Access Compliance Report

Public Rights-of-Way

(Curb Ramps)

Intersection ID: 4394	Main Street: OLD_STATESVILLE_RD	Cross Street: VICTORIA_AV	Location: SW
ADA ID: FADB5B0ECC2A	Ramp Type: PerpDiag	Initial Pass/Fail: Fail	Overall Compliance: No
Severity Score: 21.25			
Codes/Mitigation Info/Possible Solution		Field Measurements/Component Compliance

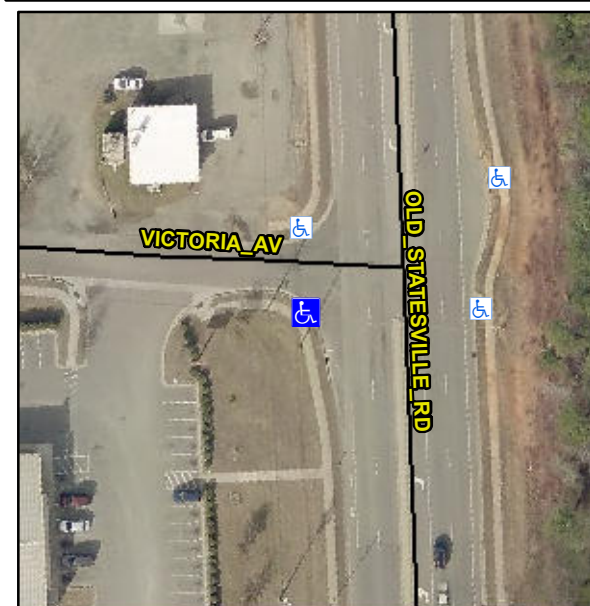
Not Found, R304.5.1, R304.2.2

Compliance	Description	Data	Compliance	Description	Data
N/A	Ramp Length (in)	61.0	No	Ramp Slope (%)	9.8
No	Ramp Width (in)	37.5	Yes	Ramp XSlope (%)	0.9
N/A	Flare Type LT	N/A	N/A	Flare Type RT	N/A
N/A	Flare Slope LT (%)	N/A	N/A	Flare Slope RT (%)	N/A
N/A	Flare Traversable LT?	N/A	N/A	Flare Traversable RT?	N/A
N/A	Landing Length (in)	N/A	N/A	DWS Provided?	N/A
N/A	Landing Width (in)	N/A	N/A	DWS Contrast?	N/A
N/A	Landing Slope (%)	N/A	N/A	DWS Length (in)	N/A
N/A	Landing X Slope (%)	N/A	N/A	DWS Full Width?	N/A
N/A	Landing Curb? (Y/N)	N/A	N/A	DWS Offset (in)	N/A
N/A	Shared Landing?	N/A			
N/A	Gutter Ponding?	N/A	N/A	Gutter Slope (%)	N/A
N/A	Gutter Lip Ht (in)	N/A	N/A	Gutter X Slope (%)	N/A
N/A	Painted X Walk1?	No	N/A	Painted X Walk2?	No
	X Walk 1 Direction	To E		X Walk 2 Direction	To N
N/A	X Walk 1 Width (in)	N/A	N/A	X Walk 2 Width (in)	N/A
	X Walk 1 Slope (%)	1.1		X Walk 2 Slope (%)	0.1
	X Walk 1 X Slope (%)	0.4		X Walk 2 X Slope (%)	0.5

Remove & Replace Curb Ramp With Two New Directional Ramps or Equivalent.
